# HISTORIC LANDMARK COMMISSION JULY 25, 2016 APPLICATION FOR A CERTIFICATE OF APPROPRIATENESS LHD-2016-0013 207 E. 44<sup>th</sup> Street Hyde Park

Enclose an existing open covered patio.

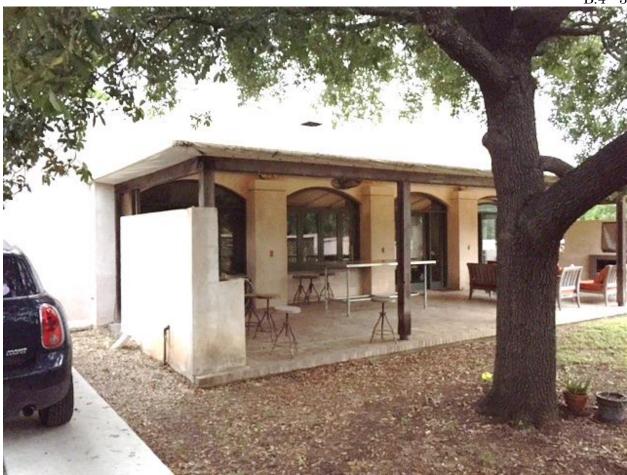
The Committee was split. One committee member was concerned with compromising the linear configuration of the house that is reminiscent of the architecture of old Roma and the Rio Grande Valley. The other committee members recommended approval of the proposal and noted that the permeability of the enclosure did not detract from the original architecture of the house.

Approve as proposed.
